Sent: 28/01/2021 1:15:34 PM
Subject: 12 Ponsonby Parade Seaforth NSW 2092 DA 2021/0008 WRITTEN
SUBMISSION: LETTER OF OBJECTION Submission: Wheeler
Attachments: Wheeler submission.docx;

SUBMISSION: WHEELER
a written submission by way of objection to DA 2021/0008

Re:
12 Ponsonby Parade Seaforth NSW 2092
DA 2021/0008

the construction of a seniors housing development incorporating 9 x in-fill self-care apartment style dwellings and basement car parking for 19 vehicles pursuant to the provisions of State Environmental Planning Policy (Housing for Seniors or People with a Disability) 2004 ("SEPP HSPD").

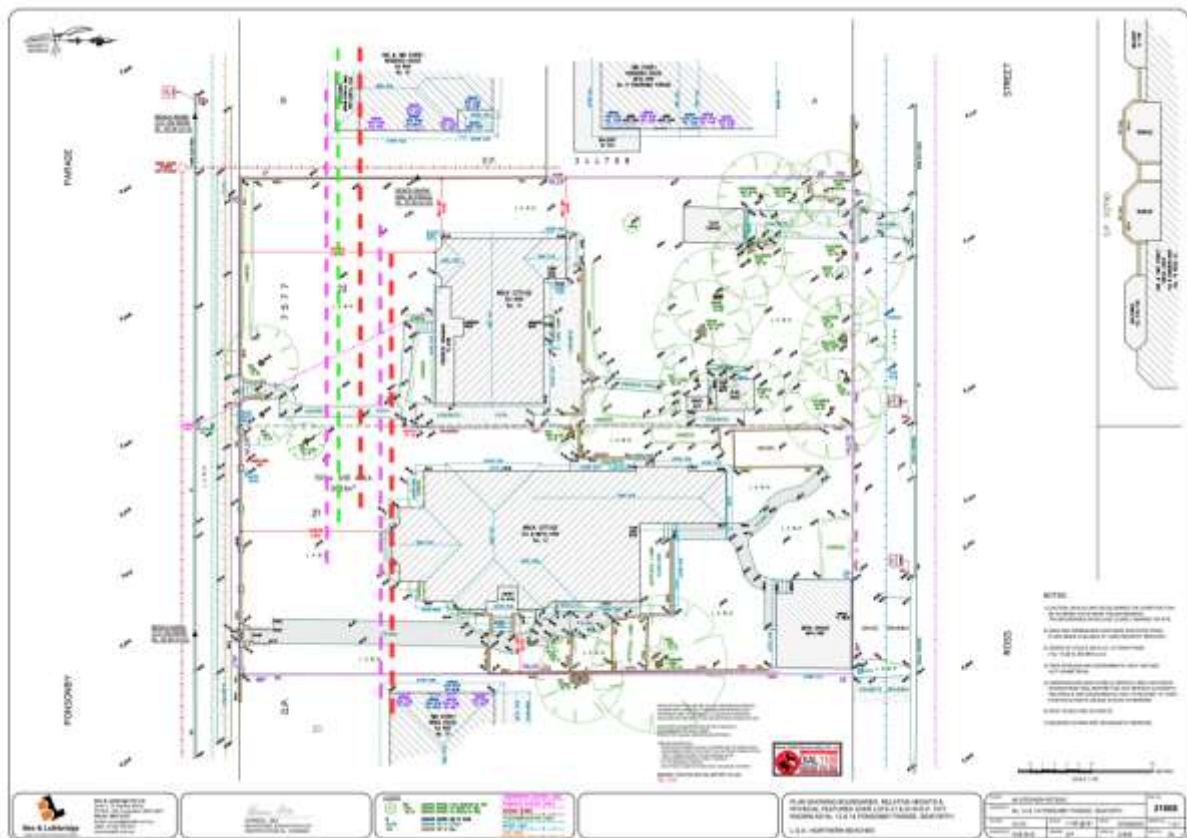
>8m. Non-compliant exceeds 8m. [East Elevation, Section 1, Section 4]

> Single Storey in Rear 25% of the total site area. Non-compliant as no part of the proposed development is single storey.

6. **Lack of modulation and raised plinth.** Continuous 'block' forms over 33m long, rather than multiple [four] pavilions to break up the mass, and to respond better to neighbour's dwellings. The ground

floor is positioned 2.8m above street level, presenting a significant 4m walled frontage to the streetscape.

Figure 10 - Shadow effect

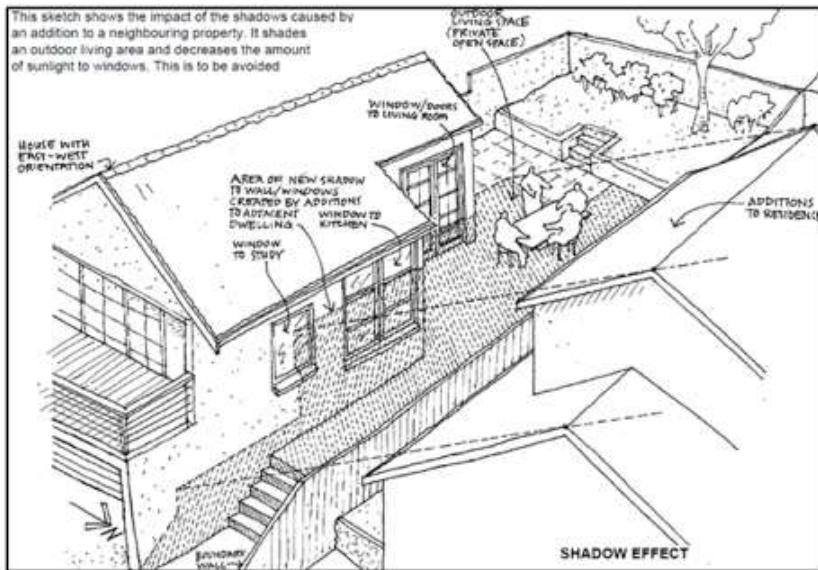
We ask for a compliant 8.5m maximum building height, and compliant side setback to allow more reasonable solar access.

We ask Council to obtain from the Applicant hourly overshadowing morning elevational drawings of our northern windows.

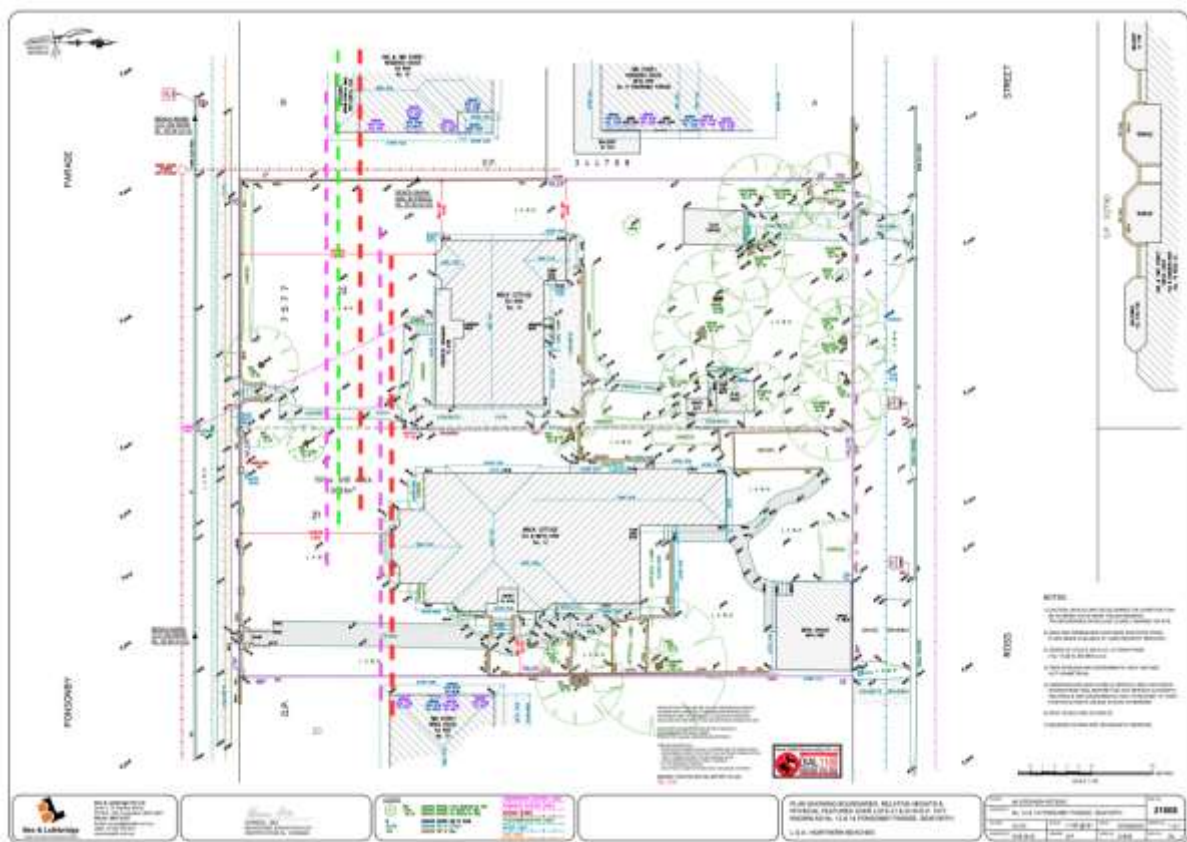
We contend that the proposed dwelling must align with our external wall zones of our dwelling and that of our neighbours dwelling.
